MARSDEN PARK NEW PRIMARY SCHOOL

**DISABILITY DISCRIMINATION ACT (DDA)
SSD SUBMISSION REPORT**

JULY 2019

Report reference 19219R02-Marsden Park DDA

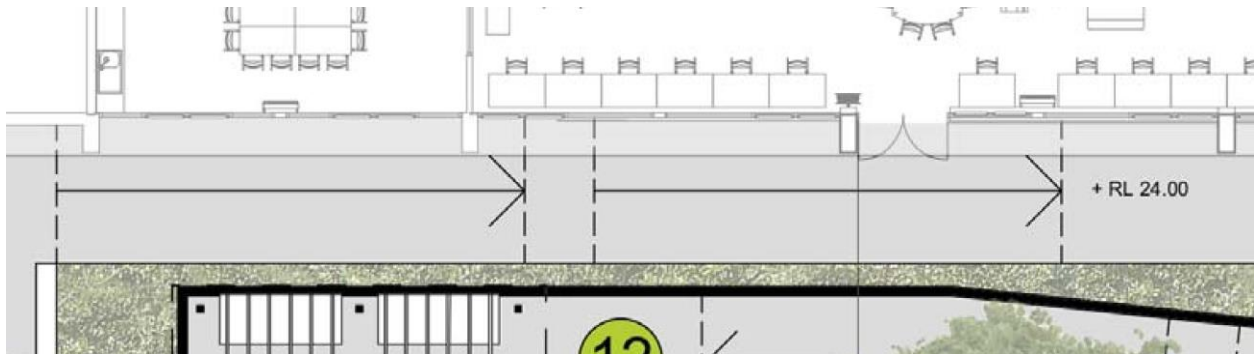
The landing to the walkway to the south of the library should be adjusted so that the double doors open to the external landing.

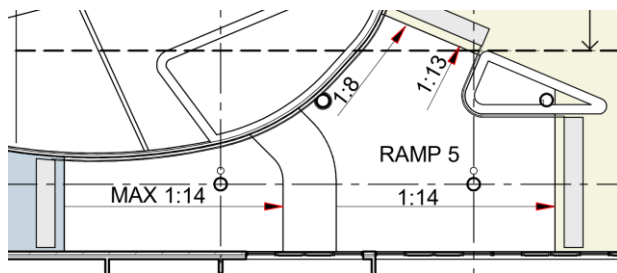
The ramp adjacent to the library exceeds the maximum gradient of 1:14. Furthermore, two gradients are detailed on the ramp (1:8 & 1:13) which is not compliant with AS 1428.1-2009. The ramp should be revised to delete the 1:8 / 1:13 section and just to have one continuous straight ramp.

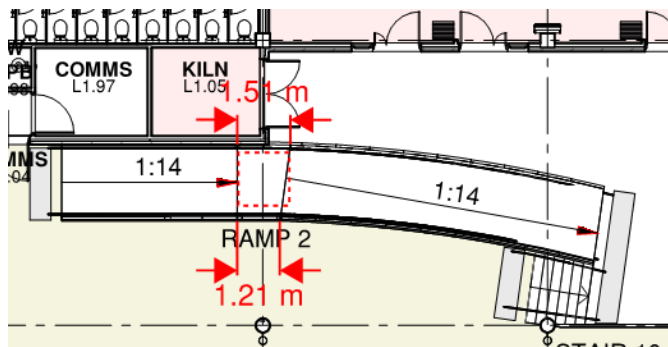
The landing to Ramp 2 is detailed as less than the minimum requirement of 1500mm.

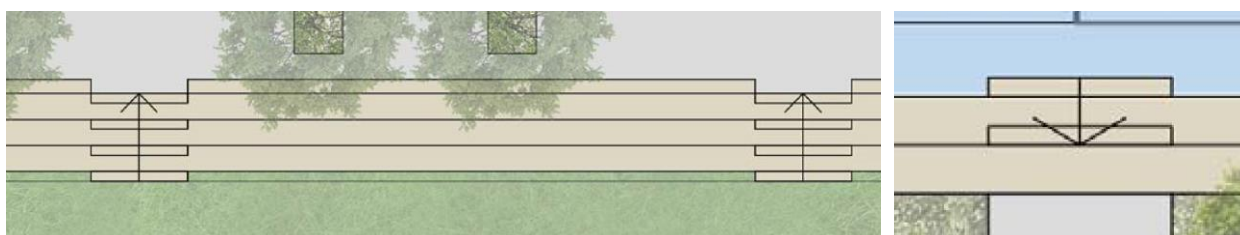
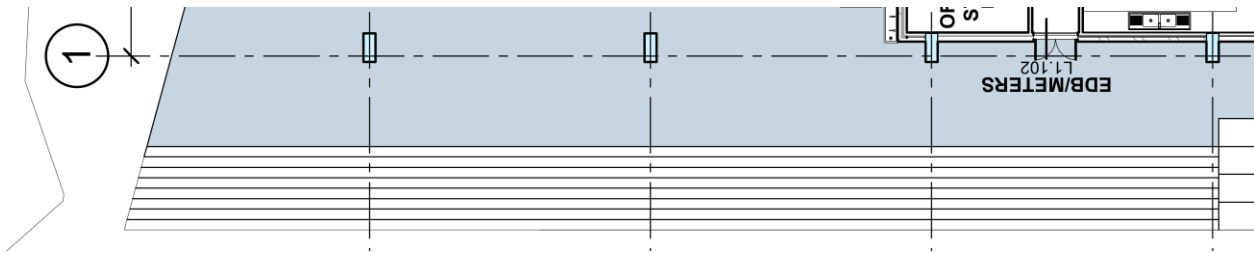
The following stairs do not have handrails located on both sides of the stairs, do not have a clear width of at least 1m and are not provided with stair numbers. If they are not provided with handrails to both sides of the stairs and are not a minimum width of 1m they are required to be justified in a performance solution.

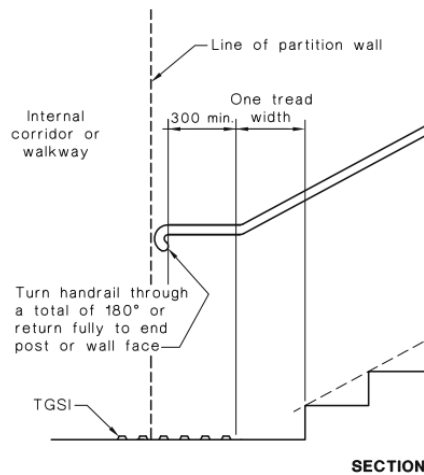
The stairs in the landscaped areas are required to comply with the requirements of As1428.1 2009 and AS1428.4.1 2009. Note that the requirement for handrails to be provided to both sides of stairs also applies to the stairs to the soccer field, sports court and the curved stairs outside the canteen.

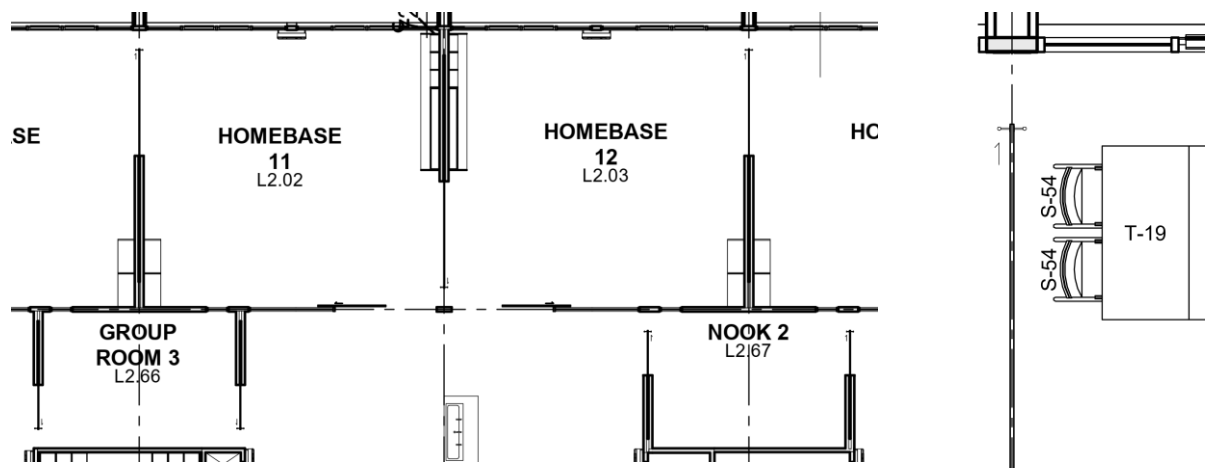
The door handles to the sliding doors to the homebases, nooks and group rooms are required to be set back a minimum distance of 400mm from internal corner formed by the folding walls and nibs so that they provide a latch side circulation space.

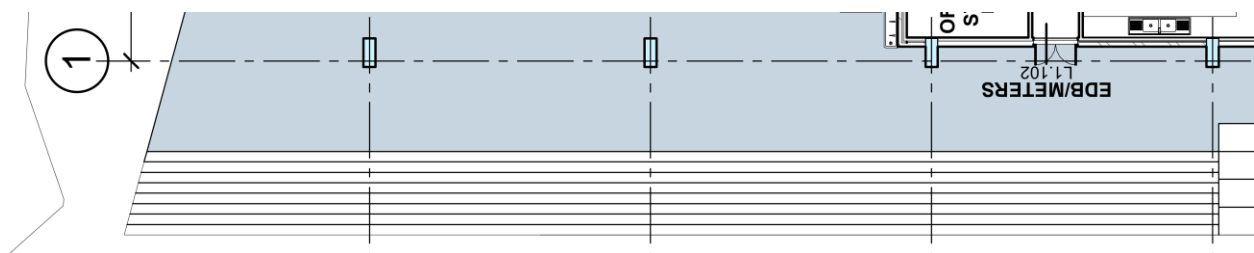
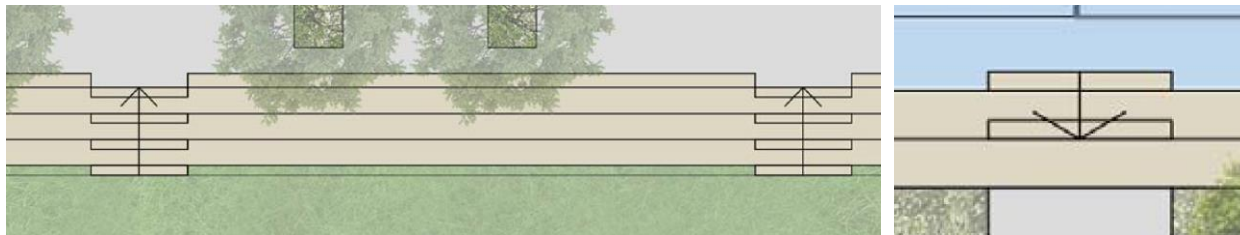
The stairs to the side of the tiered seating in the level 1 courtyard are required to be provided with tactile indicators to the top and bottom as per AS1428.4.1 2009.

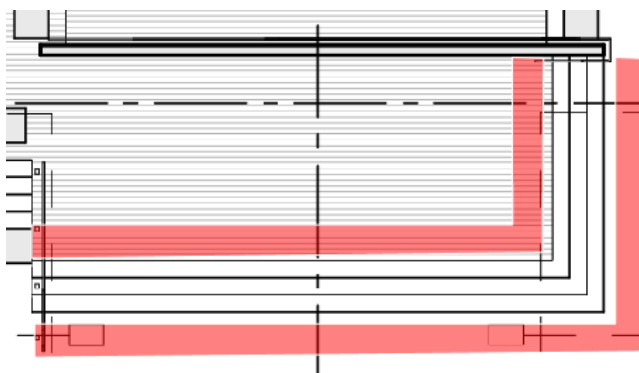
The stairs to the soccer field, sports court and the stairs outside the canteen are required to be provided with tactile indicators to the top and bottom as per AS1428.4.1 2009.

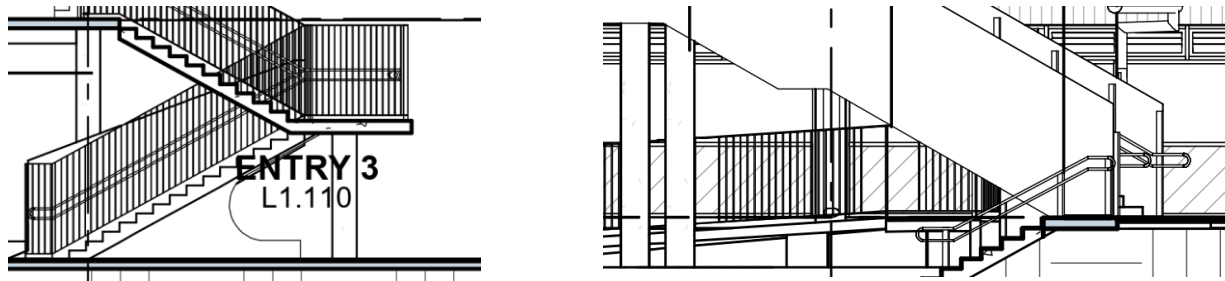
The stairs at the front of the stage are required to be provided with tactile indicators to the top and bottom as per AS1428.4.1 2009.

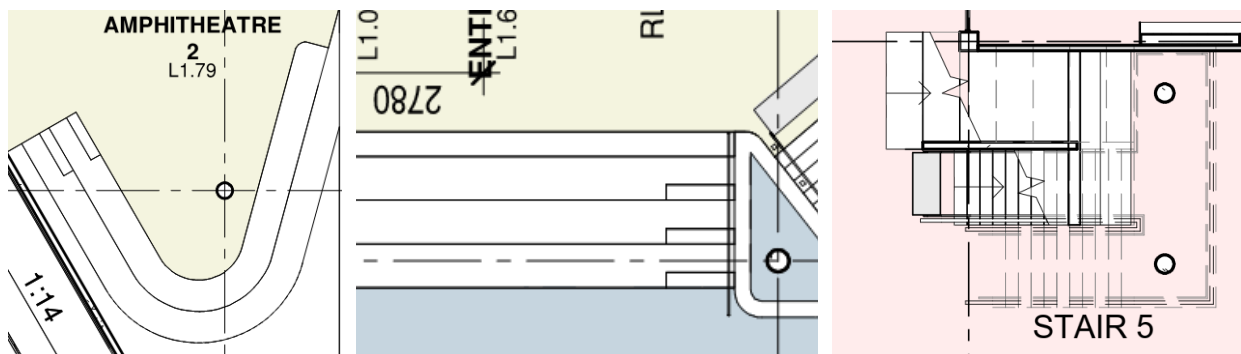
The amphitheatre seating and the tiered seating beside stair 5 is deemed to be fixed seating in a Class 9b building and is required to be provided with wheelchair seating spaces as per the BCA and AS1428.1 2009.

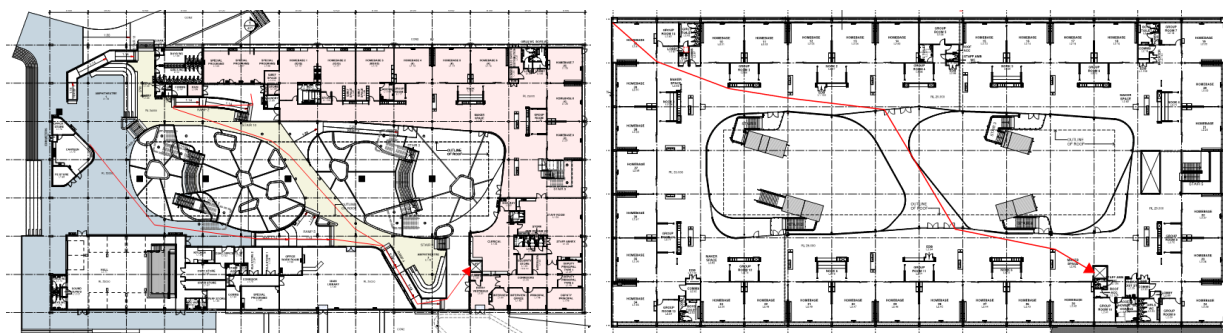
The location of the lift on the eastern side of the building means that the occupants of the western side of level 2 will have to travel a longer distance to access the unique services located on the western side of level 1 such as the Special Programs rooms, the Canteen and the Hall. This is a non compliance to the requirements of the DDA.
